[ERRATA - PIC24FJ256GB110 Family Silicon/Data Sheet Errata](#)

Product Change Notification - SYST-15QPMT193

PIC24FJ256GB110 Family Silicon Errata and Data Sheet Clarification

The PIC24FJ256GB110 family devices that you have received conform functionally to the current Device Data Sheet (DS39897C), except for the anomalies described in this document.

FIGURE 2-3 FREQUENCY vs. ESR PERFORMANCE FOR SUGGESTED VCAP

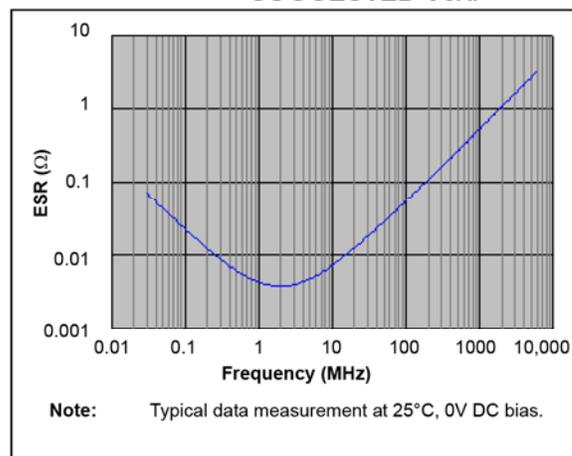
Section 2.4 Voltage Regulator Pins (ENVREG/DISVREG and VCAP/VDDCORE) has been replaced with a new and more detailed section. The entire text follows:

When the regulator is enabled, a low-ESR ($< 5\Omega$) capacitor is required on the VCAP/VDDCORE pin to stabilize the voltage regulator output voltage. The VCAP/VDDCORE pin must not be connected to VDD and must use a capacitor of 10 μF connected to ground. The type can be ceramic or tantalum. Suitable examples of capacitors are shown in **Table 2-1**. Capacitors with equivalent specifications can be used.

Designers may use **Figure 2-3** to evaluate ESR equivalence of candidate devices.

FIGURE 2-4 DC BIAS VOLTAGE vs. CAPACITANCE CHARACTERISTICS

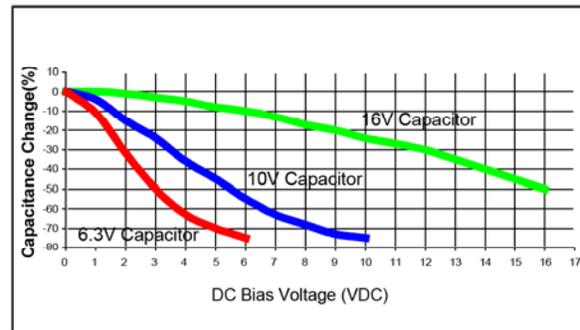
In addition to temperature tolerance, the effective capacitance of large value ceramic capacitors can vary substantially, based on the amount of DC voltage applied to the capacitor. This effect can be very significant, but is often overlooked or is not always documented.

A typical DC bias voltage vs. capacitance graph for 16V, 10V and 6.3V rated capacitors is shown in Figure 2-4.

When selecting a ceramic capacitor to be used with the internal voltage regulator, it is suggested to select a high-voltage rating, so that the operating voltage is a small percentage of the maximum rated capacitor voltage. For example, choose a ceramic capacitor rated at 16V for the 2.5V core voltage. Suggested capacitors are shown in Table 2-1.
